Value Engineering Study Report
Flood Control District of Maricopa County
McMicken Dam Project

June 2015

**RE: McMicken Dam Project
Value Engineering Study Report - FINAL**

VALUE ENGINEERING PROPOSAL CF-11
Flood Control District of Maricopa County
McMicken Dam Project

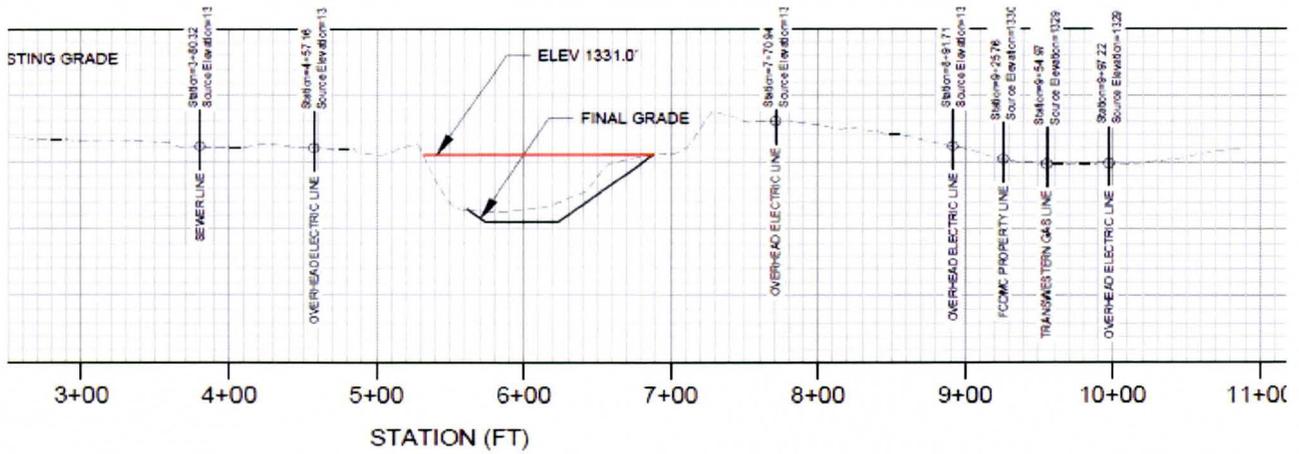
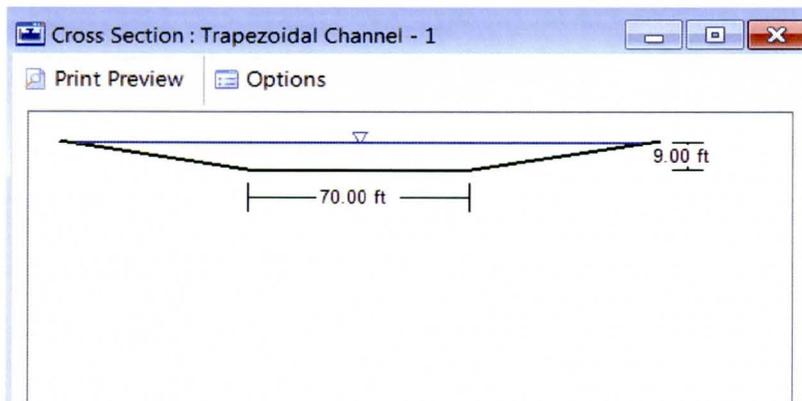
TITLE: Widen outlet channel east of the US60			
FUNCTION: Convey 100-year Flood			
BASELINE ASSUMPTION:			
Baseline is the 15% design alternative 3. Channel has 50-foot bottom width and 6:1 side slopes. Existing 15% design alternative 3 transitions north at approximately Station 112+00.			
PROPOSED ALTERNATIVE:			
Widen bottom width of the channel 20 feet to accommodate the 5,000 cfs discharge below existing grade (no levee is required).			
BENEFITS		RISKS/CHALLENGES	
<ul style="list-style-type: none"> No levee is required 		<ul style="list-style-type: none"> Proximity to power towers, need 50-foot clearance 	
<ul style="list-style-type: none"> Construction is simplified 		<ul style="list-style-type: none"> Proximity to existing road (with underground utilities), limited real estate 	
<ul style="list-style-type: none"> Reduces risk 		<ul style="list-style-type: none"> Increases excavation into possible cemented soils

Widening the channel with the intent of accommodating the 5,000 cfs discharge (below existing grade) would allow removal of the existing levee condition. This scenario would reduce risk and also represent significant cost savings.

Preliminary Flowmaster calculations show that increasing the channel bottom by 20 feet (increase from 50 feet to 70 feet) allows for the 5,000 cfs flow to be conveyed by the channel (below existing grade). The existing channel segment is within close proximity of the existing power poles and this must be taken into consideration. VE team has concern that there is not enough real estate to allow for the channel widening.

VALUE ENGINEERING PROPOSAL CF-12
Flood Control District of Maricopa County
McMicken Dam Project

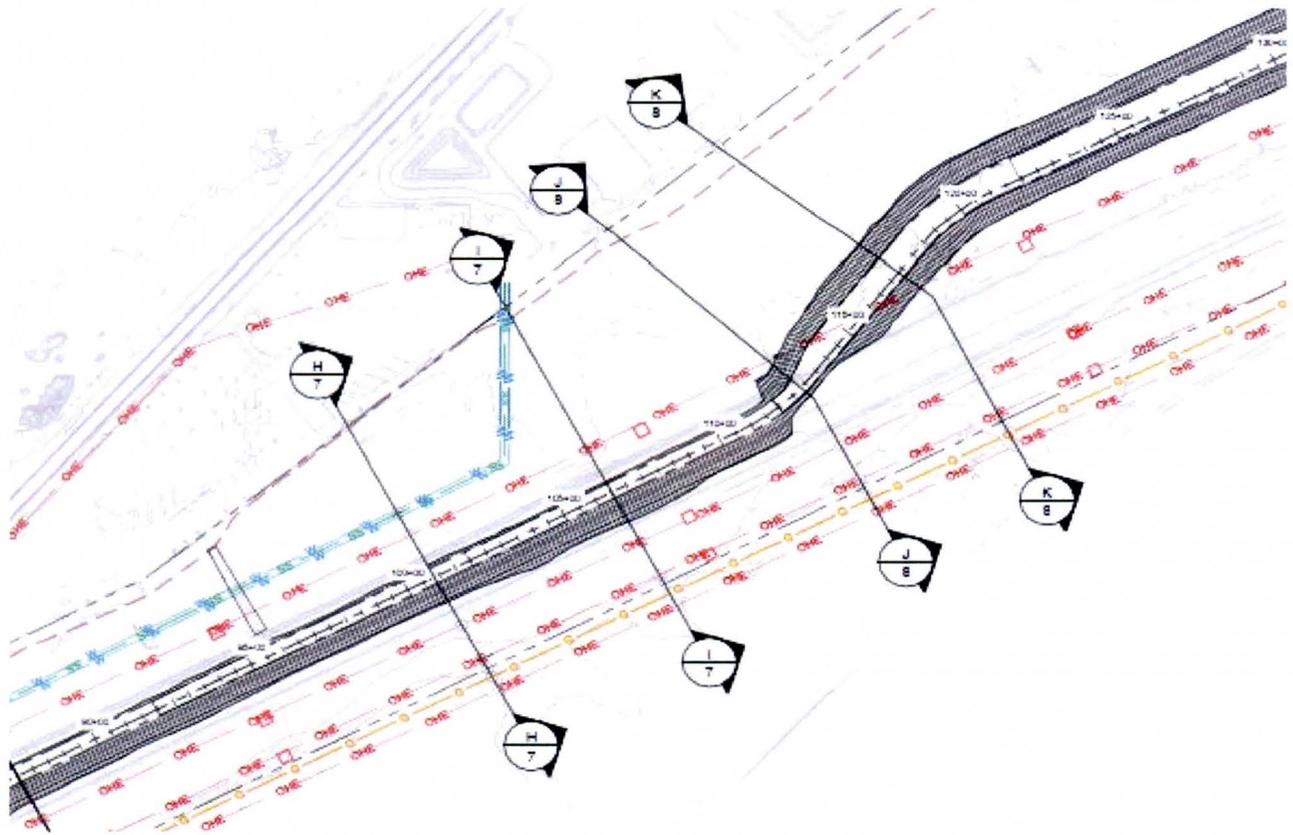
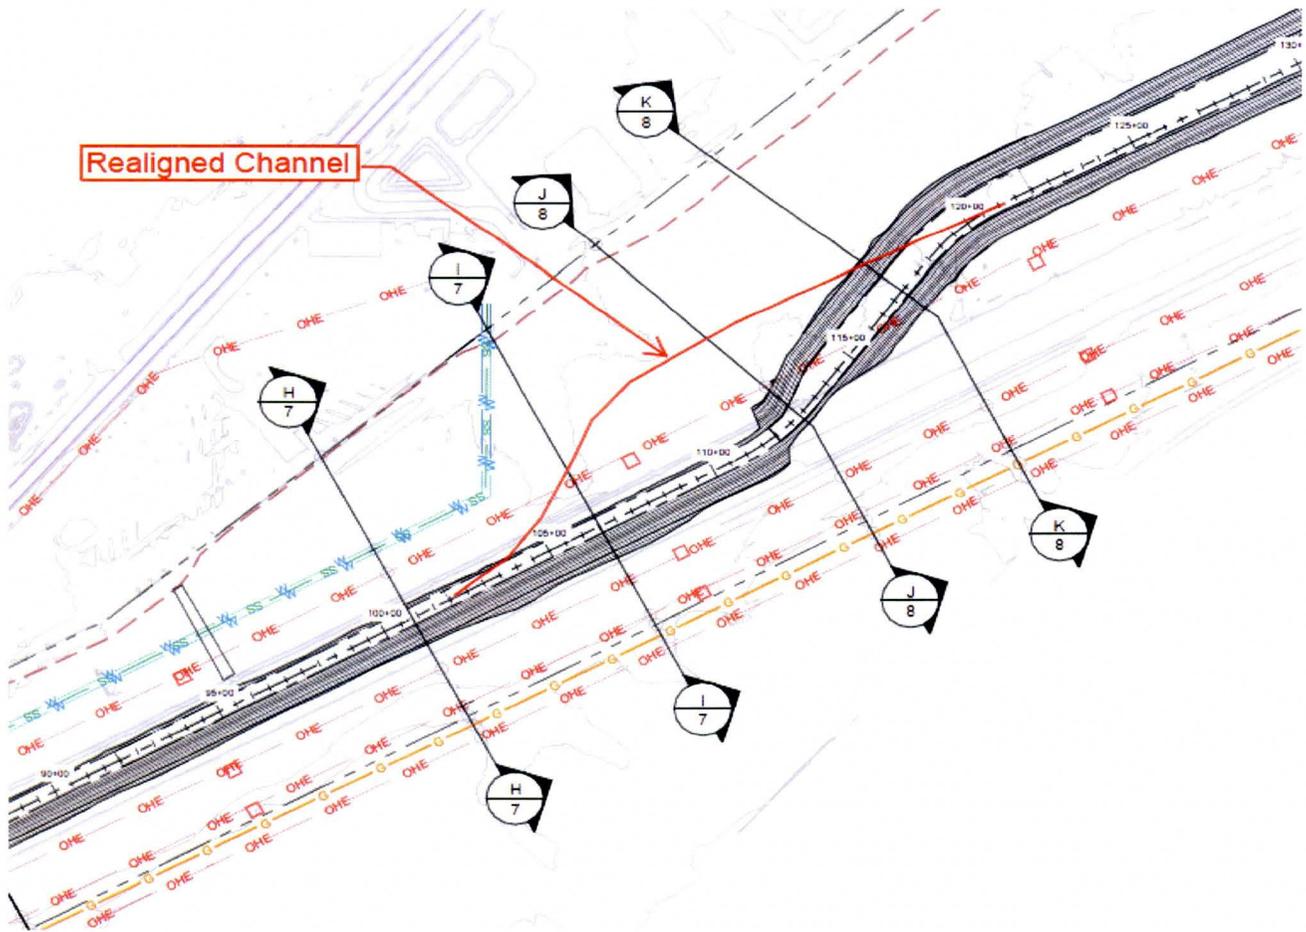
TITLE: Transition outlet channel to north at approximately Station 102+00																			
FUNCTION: Convey 100-year Flood																			
BASELINE ASSUMPTION: Baseline is the 15% design alternative 3. Channel has 50-foot bottom width and 6:1 side slopes. The existing 15% design alternative 3 transitions north at approximately Station 112+00.																			
PROPOSED ALTERNATIVE: Proposed alternative would transition the outlet channel to the north sooner, approximately at Station 102+00.																			
BENEFITS		RISKS/CHALLENGES																	
<ul style="list-style-type: none"> Reduces length of levee condition 		<ul style="list-style-type: none"> Reduces possible land for sale 																	
<ul style="list-style-type: none"> Reduces risk by minimizing use of the levee 		<ul style="list-style-type: none"> Close proximity to power towers, 50-foot clearance required 																	
<ul style="list-style-type: none"> 		<ul style="list-style-type: none"> Possible increased excavation into cemented soils 																	
<ul style="list-style-type: none"> 		<ul style="list-style-type: none"> 																	
<ul style="list-style-type: none"> 		<ul style="list-style-type: none"> 																	
<ul style="list-style-type: none"> 		<ul style="list-style-type: none"> 																	
<ul style="list-style-type: none"> 		<ul style="list-style-type: none"> 																	
<ul style="list-style-type: none"> 		<ul style="list-style-type: none">

Transition the new channel to the north 1,000 feet sooner, reducing the length of levee required. This scenario would reduce risk and represent some cost savings.

The realigned channel needs to consider the 50-foot clearance from the power towers and the existing roadway.

VALUE ENGINEERING PROPOSAL CF-14
Flood Control District of Maricopa County
McMicken Dam Project

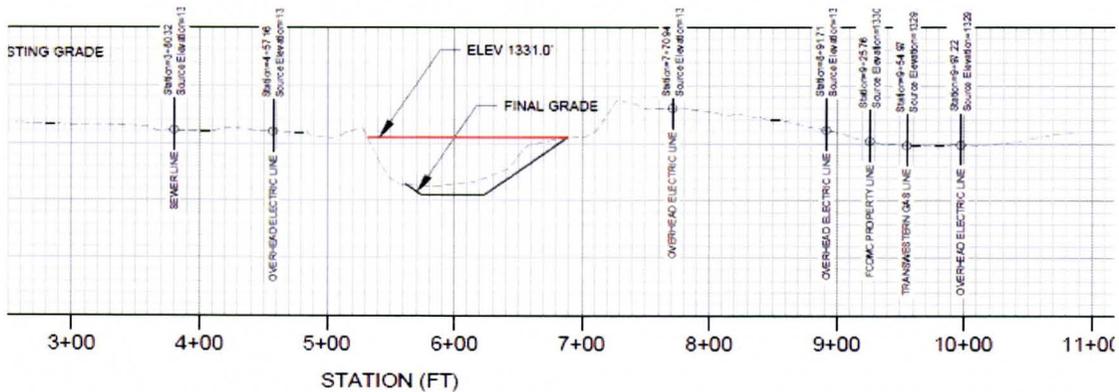
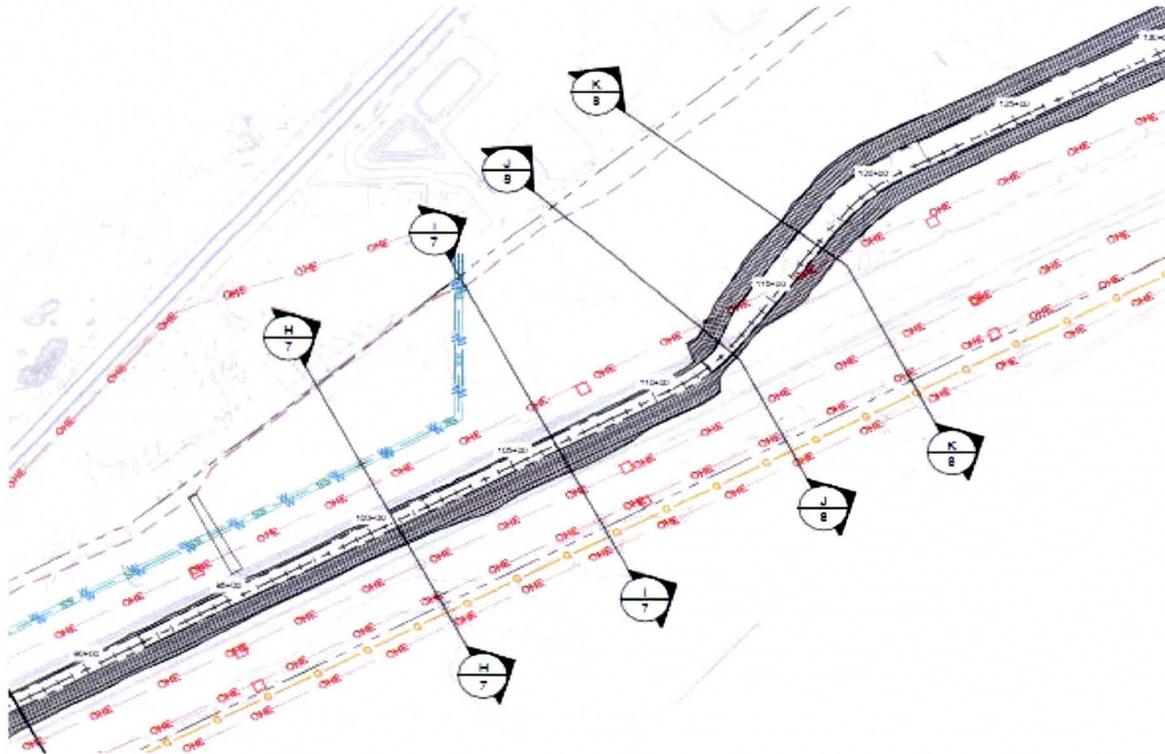
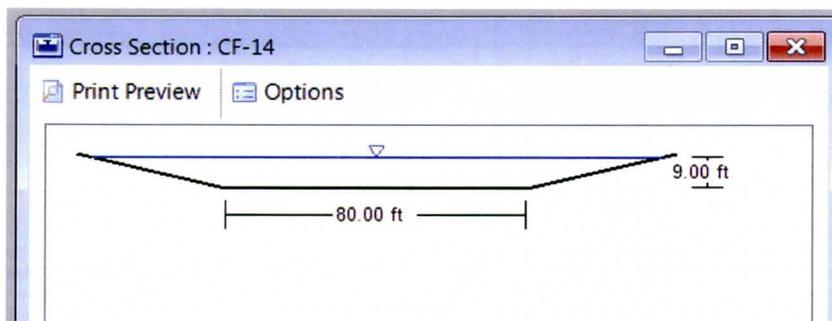
TITLE: Steepen side slopes to widen channel																							
FUNCTION: Convey 100-year Flood																							
BASELINE ASSUMPTION: Baseline is the 15% design alternative 3. Channel has 50-foot bottom width and 6:1 side slopes. Existing 15% design alternative 3 transitions north at approximately Station 112+00.																							
PROPOSED ALTERNATIVE: Steepen slopes to 4:1 to increase conveyance area while maintaining the same channel footprint.																							
BENEFITS		RISKS/CHALLENGES																					
<ul style="list-style-type: none"> Removes levee condition 		<ul style="list-style-type: none"> Would require design waiver for steepening side slopes from 6:1 to 4:1 without erosion protection 																					
<ul style="list-style-type: none"> Reduces risk by removing levee condition 		<ul style="list-style-type: none"> 																					
<ul style="list-style-type: none"> Avoids clearance conflicts with power towers 		<ul style="list-style-type: none"> 																					
<ul style="list-style-type: none"> May reduce O&M due to levee elimination; however, could increase maintenance due to steeper side slopes 		<ul style="list-style-type: none"> 																					
<ul style="list-style-type: none"> 		<ul style="list-style-type: none"> 																					
<ul style="list-style-type: none"> 		<ul style="list-style-type: none"> 																					
<ul style="list-style-type: none"> 		<ul style="list-style-type: none"> 																					
<ul style="list-style-type: none"> 		<ul style="list-style-type: none">

This idea steepens the side slopes of the channel from 6:1 to 4:1 to increase the channel conveyance area. The steeper side slopes allows for the channel footprint to remain the same while increasing capacity, conveying the 5,000 cfs flow below existing grade.

The existing outlet channel side slopes are steeper (approximately 2.5:1) and have no major erosion problems after 50 plus years of service.

Steepening the side slopes from 6:1 to 4:1 would require a design waiver from current District standards for slopes without erosion protection. The steeper slopes could possibly increase maintenance requirements.

VALUE ENGINEERING PROPOSAL CF-15
Flood Control District of Maricopa County
McMicken Dam Project

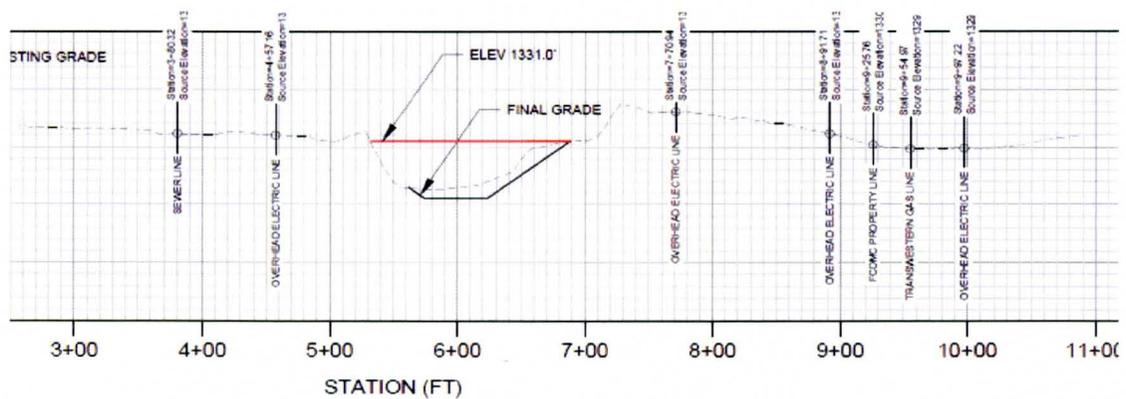
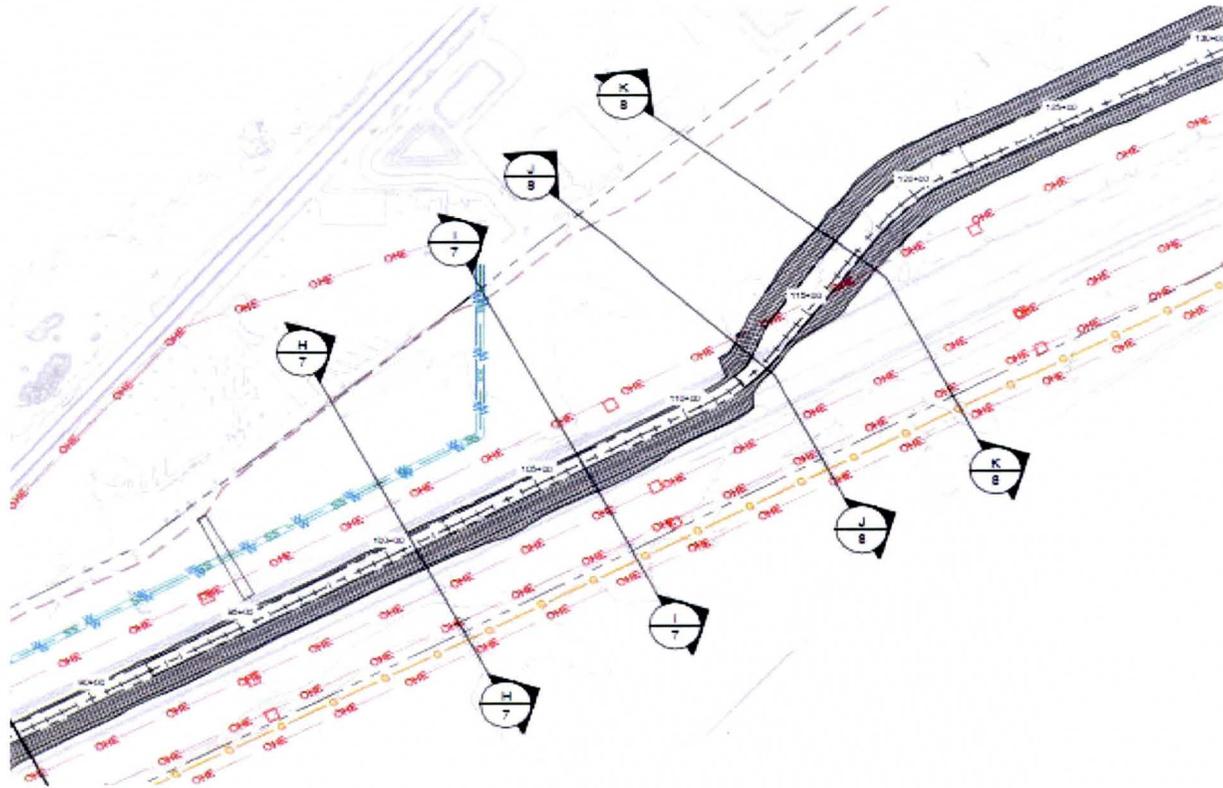
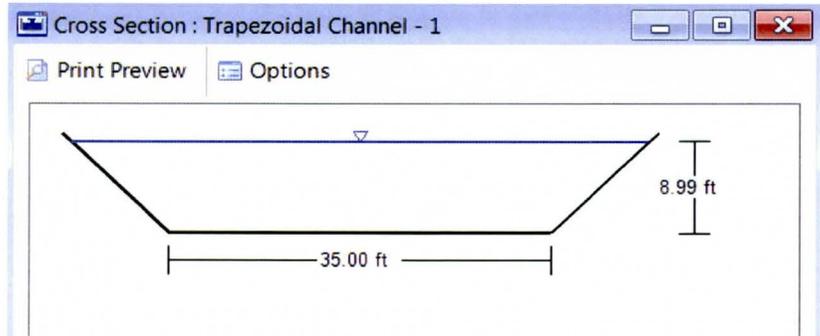
TITLE: Line channel with concrete to avoid levee			
FUNCTION: Convey 100-year Flood			
BASELINE ASSUMPTION:			
Baseline is the 15% design alternative 3. Channel has 50-foot bottom width and 6:1 side slopes. Existing 15% design alternative 3 transitions north at approximately Station 112+00.			
PROPOSED ALTERNATIVE:			
Proposed alternative would use a trapezoidal concrete-lined channel to improve conveyance and reduce the channel footprint.			
BENEFITS		RISKS/CHALLENGES	
● Removes levee condition		● Lack of aesthetic feature	
● Reduces risk by removing levee condition		●	
● Reduces maintenance		●	
● Reduces footprint		●	
●		●	
●		●	
●		●	
●		●	
COST SUMMARY		Initial Costs	O&M Costs
BASELINE ASSUMPTION:		\$ 1,339,585	\$ -
PROPOSED ALTERNATIVE:		\$ 2,330,384	\$ -
TOTAL (Baseline less Proposed)		\$ (990,799)	\$ -
		COST

Use concrete retaining walls to increase conveyance area and remove levee condition. This reduces risk of failure by removing the levee. There are reduced maintenance costs with the concrete channel. Also, the concrete channel has a smaller footprint and would mitigate clearance issues with power towers.

Constructing a concrete channel is very expensive but low maintenance and would allow for the levee to be removed.

VALUE ENGINEERING PROPOSAL CF-17
Flood Control District of Maricopa County
McMicken Dam Project

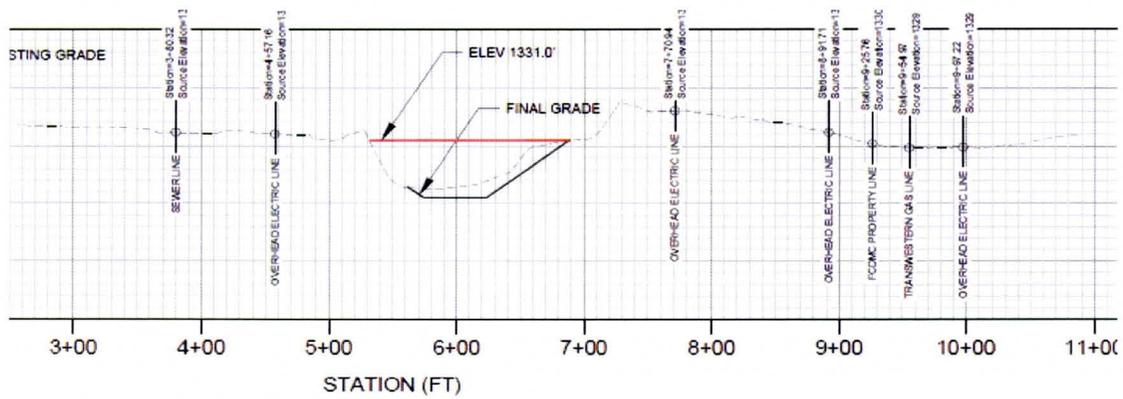
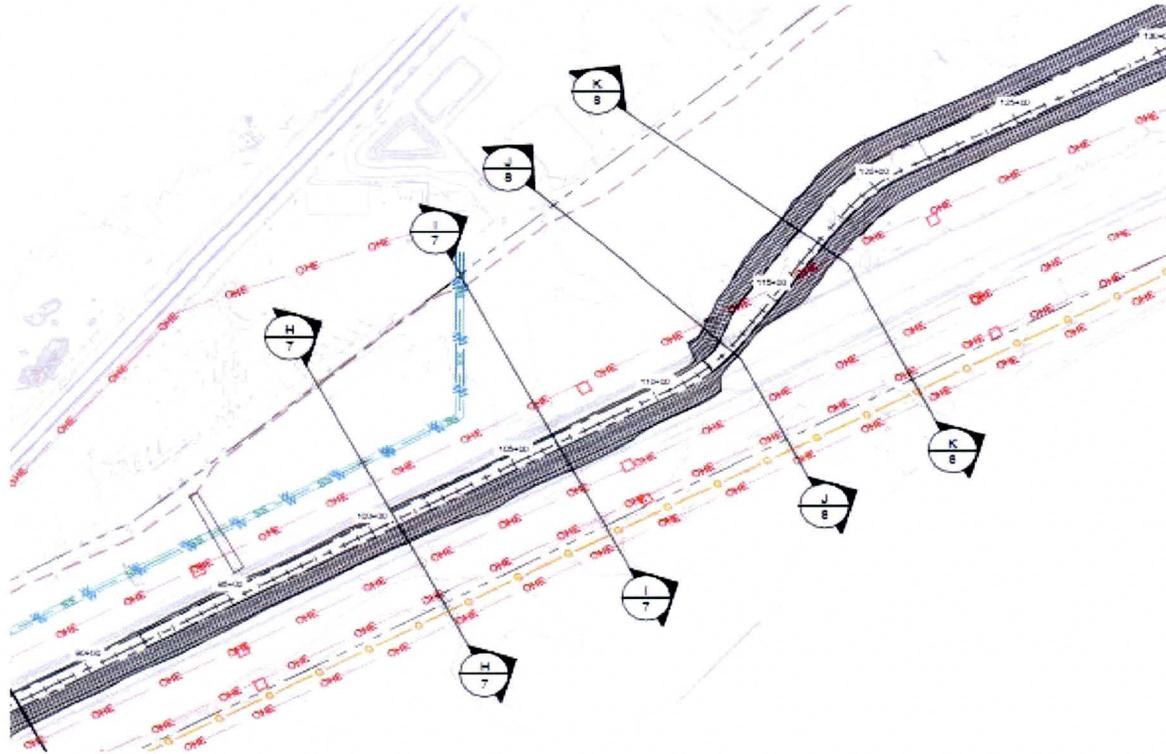
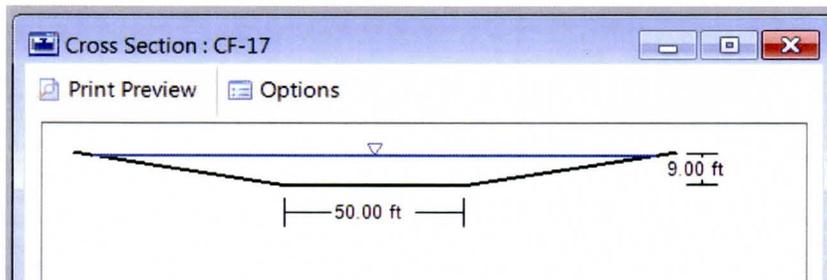
TITLE: Steepen channel slope																			
FUNCTION: Convey 100-year Flood																			
BASELINE ASSUMPTION: Baseline is the 15% design alternative 3. Channel has 50-foot bottom width and 6:1 side slopes. Existing 15% design alternative 3 transitions north at approximately Station 112+00.																			
PROPOSED ALTERNATIVE: Steepen channel bottom slope from 0.001 to 0.0015 to increase conveyance and avoid the need for a levee.																			
BENEFITS		RISKS/CHALLENGES																	
<ul style="list-style-type: none"> Removes levee condition 		<ul style="list-style-type: none"> Velocity is increased to slightly faster than 5 fps and would require design waiver 																	
<ul style="list-style-type: none"> Reduces risk by removing levee condition 		<ul style="list-style-type: none"> Requires deeper excavation (2.175') of low flow channel within the remaining downstream portion 																	
<ul style="list-style-type: none"> Reduces O&M by eliminating levee even though velocities may need to be addressed by O&M 		<ul style="list-style-type: none"> Possible increased excavation into cemented soils 																	
<ul style="list-style-type: none"> 		<ul style="list-style-type: none"> 																	
<ul style="list-style-type: none"> 		<ul style="list-style-type: none"> 																	
<ul style="list-style-type: none"> 		<ul style="list-style-type: none"> 																	
<ul style="list-style-type: none"> 		<ul style="list-style-type: none"> 																	
<ul style="list-style-type: none"> 		<ul style="list-style-type: none">

Steepen channel bottom slope from 0.001 to 0.0015 to increase conveyance. The 5,000 cfs flow is conveyed in the channel (below grade) and would eliminate the need for a levee.

Steepening the channel bottom slope would require over excavation of the downstream Low Flow channel (2.175 feet deeper) to accommodate for the steeper slope in the upstream section.

TITLE: Build outlet structure with gates at existing locations

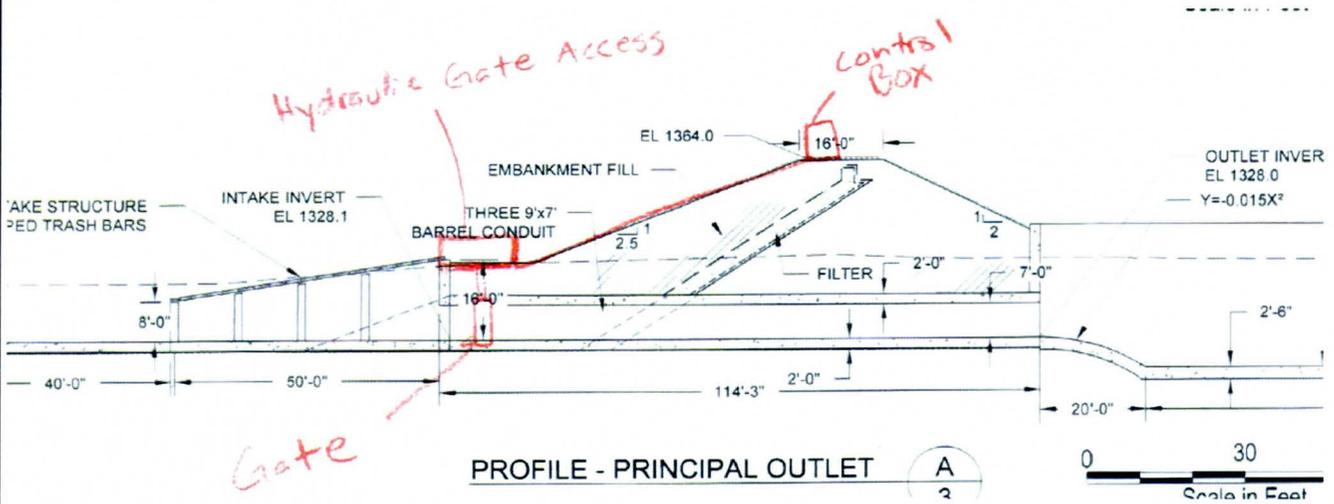
Under the existing layout, the emergency spillway flows could damage the outlet channel by filling with sediment or damage from high energy water flow. The proposed baseline moves the principal outlet to the north side of the emergency spillway to avoid this condition. The proposed alternative maintains the existing layout, but provides a means to clean or repair the channel after an emergency spillway flow. The baseline does not provide for outflow to be shut off if required (e.g., to clean outlet channel after emergency spillway event allowing remaining flows to remain in channel). The remainder of the stored water can then be safely conveyed within the outlet channel along the existing alignment.
